# Executive Director's Recommendation

<b>PROJECT</b> <b>Flood Hardening at Cleveland Park, Shaw-Howard University, and Capitol South Metrorail Stations</b> Washington, DC	<b>NCPC FILE NUMBER</b> 7812
	<b>NCPC MAP FILE NUMBER</b> 00:00(41.14)44403
<b>SUBMITTED BY</b> Washington Metropolitan Area Transit Authority	<b>APPLICANT'S REQUEST</b> Approval of comments on concept design
	<b>PROPOSED ACTION</b> Approve preliminary and final plans
<b>REVIEW AUTHORITY</b> Advisory D.C. Code § 9-1107.01, Washington Metropolitan Area Transit Authority Compact	<b>ACTION ITEM TYPE</b> Consent Calendar

**NCPC File #: 7812**  
**Flood Hardening at Cleveland Park, Shaw-Howard  
University, and Capitol South Metrorail Stations**

**Cleveland Park Metro Station**

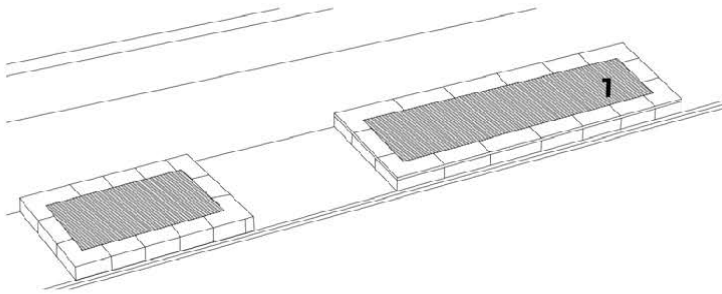
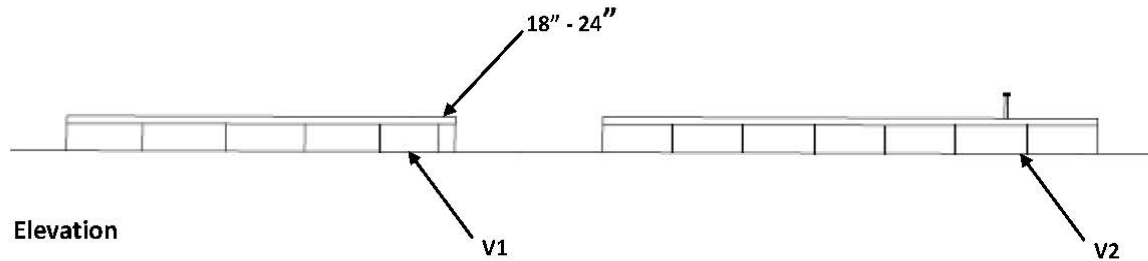
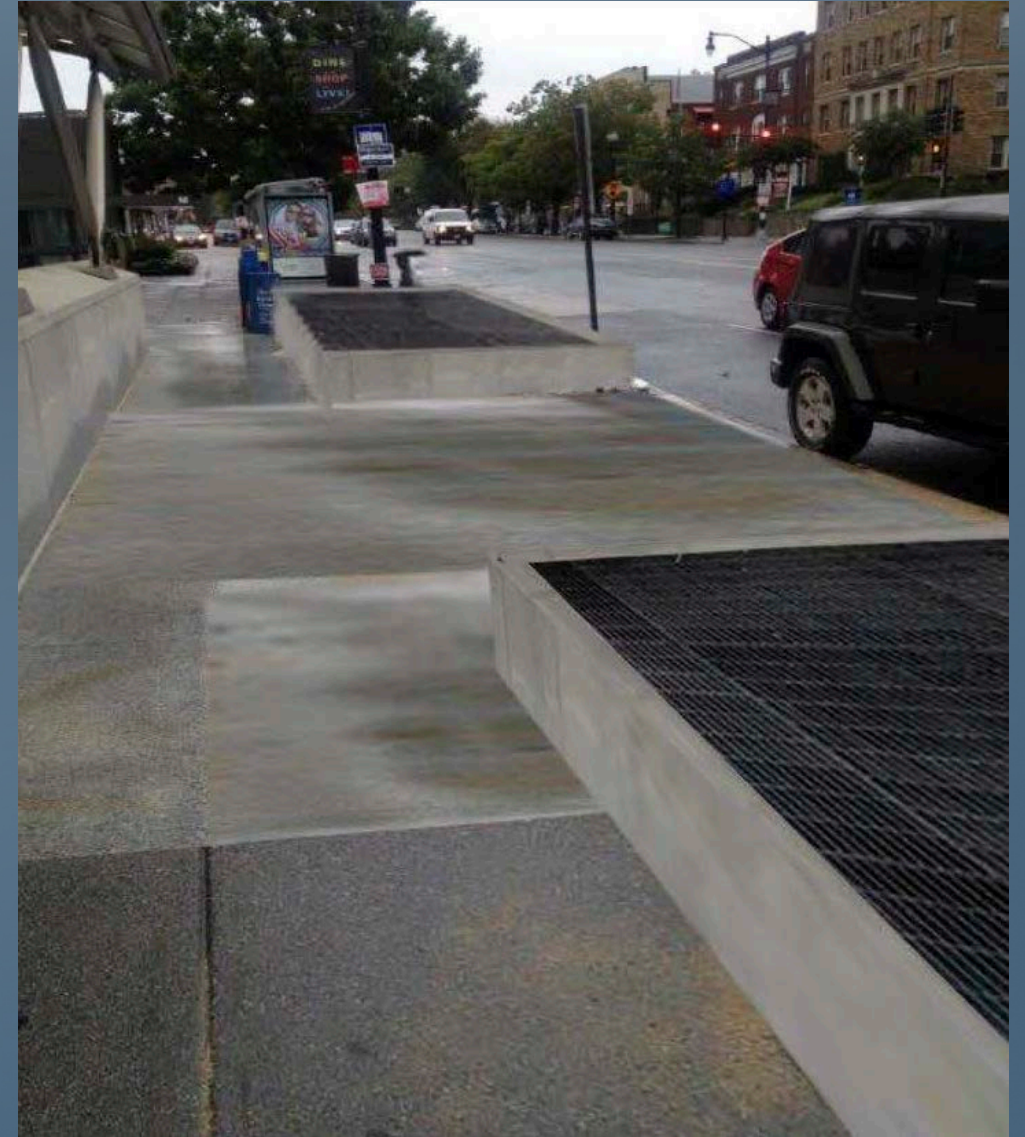
WMATA is proposing to protect two vent shafts for this Metrorail station that are located in a confined area between the existing metro escalator and the Connecticut Avenue curb. This portion of the sidewalk is heavily used by pedestrians walking both north and south of the station. Adding an 18-24 inch wall around the existing vent shafts will replace the existing sandbags that are used to temporarily protect these vents. While this will occur at a narrow section of the sidewalk which would limit the walking path at this location, WMATA states that there will be approximately a 6-foot clear area which would allow for pedestrians to pass. Staff understands that this is a very narrow area, however WMATA has described that the existing site conditions make it impossible to develop this project at another location.

**Approves** the preliminary and final site development plans for flood protection measures at three Metrorail Stations consisting of raising the elevation of existing air vent shafts.

**Howard University/Shaw Metro Station**

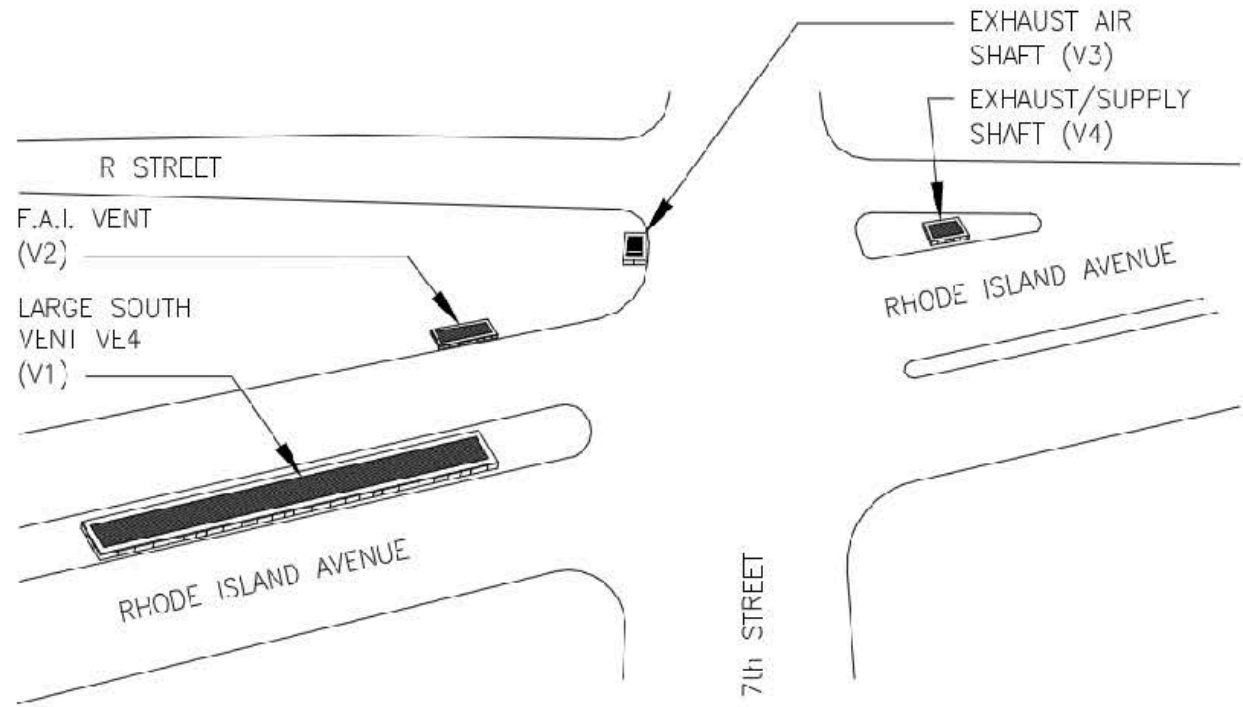
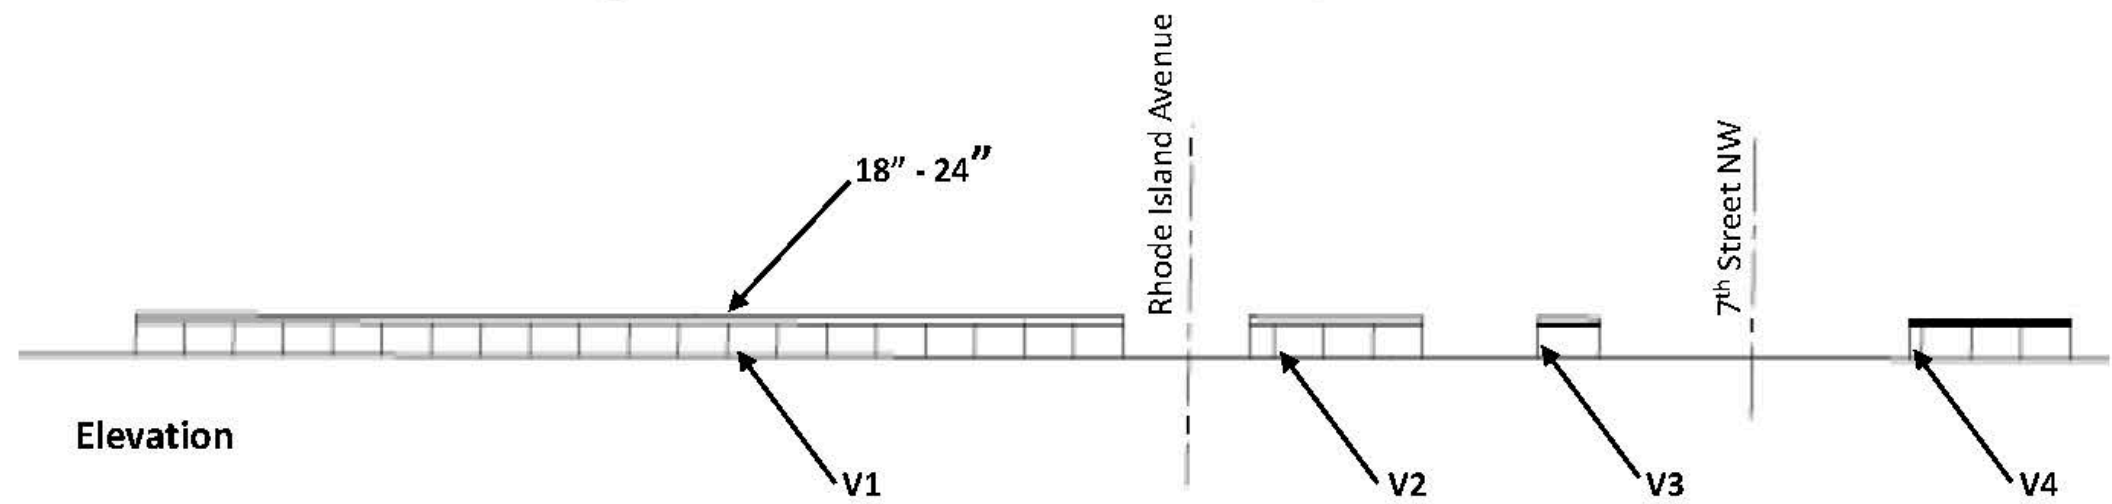
WMATA is proposing to protect four vent shafts in close proximity to the Shaw/Howard University Metrorail station. Two of the four shafts are near the Walter P. Daniel Library on Rhode Island Avenue. Staff have reviewed the plans and note that improvements to both of these shafts will be adjacent to pedestrian sidewalks and will not impact the pedestrian space. The third shaft is located in the Rhode Island Avenue median and does not pose an obstruction for pedestrians. Furthermore, it's relatively low height of 24-inches will not obstruct drivers. The final site is located on a triangular traffic island. Staff does not believe it will pose any obstructions to pedestrians or drivers.

# Capitol South Metro Station - Existing Conditions

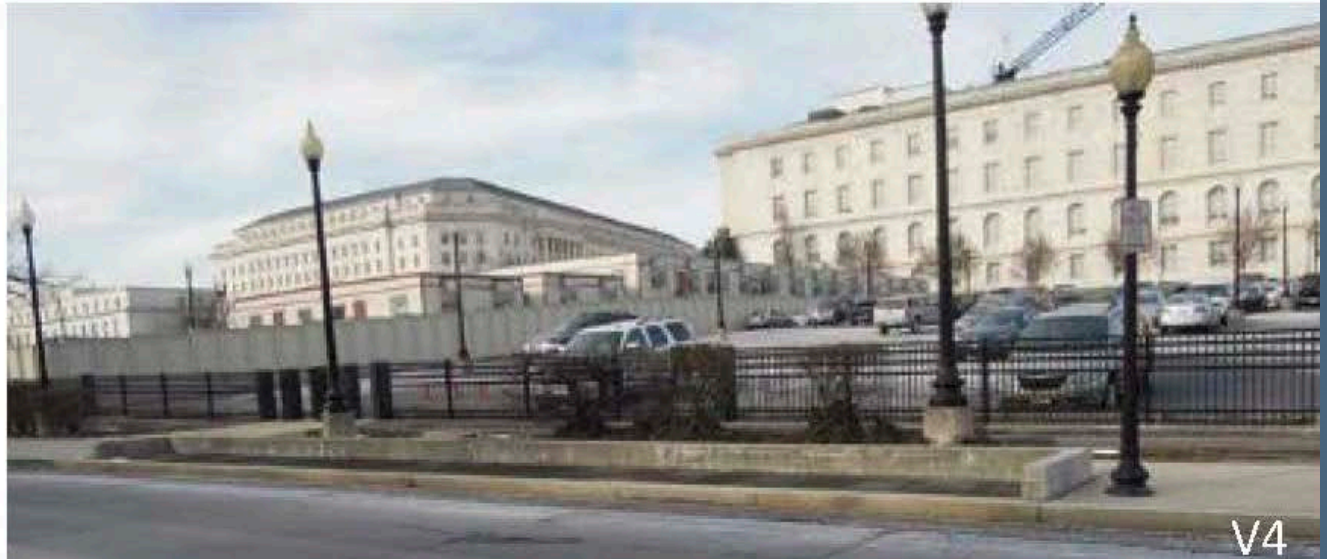
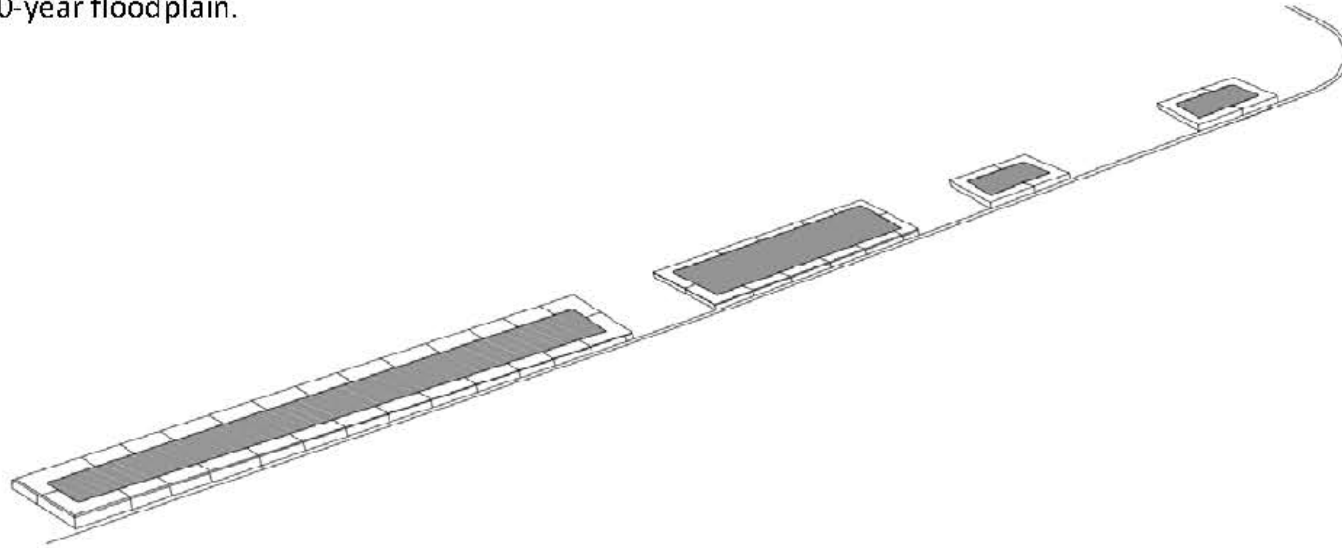
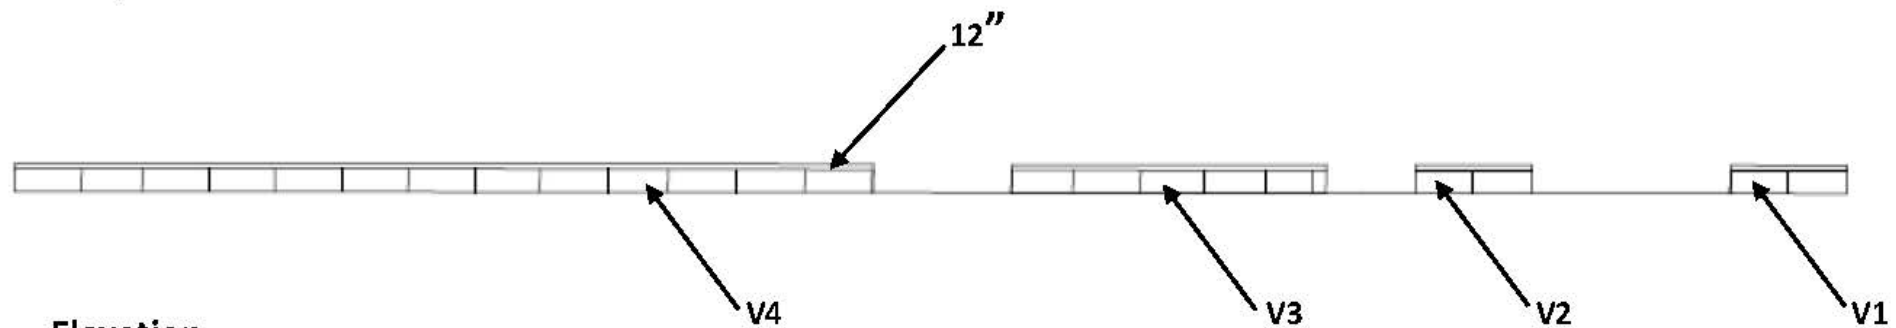
WMATA is proposing to protect four vent shafts near the Capitol South Metrorail station along D Street, SE by raising the existing vent shaft walls from 7 inches to 12 inches. Staff finds that this is a minimal change and there will be no impacts to pedestrians or the ability to park. Currently parking is not allowed on this side of the street.
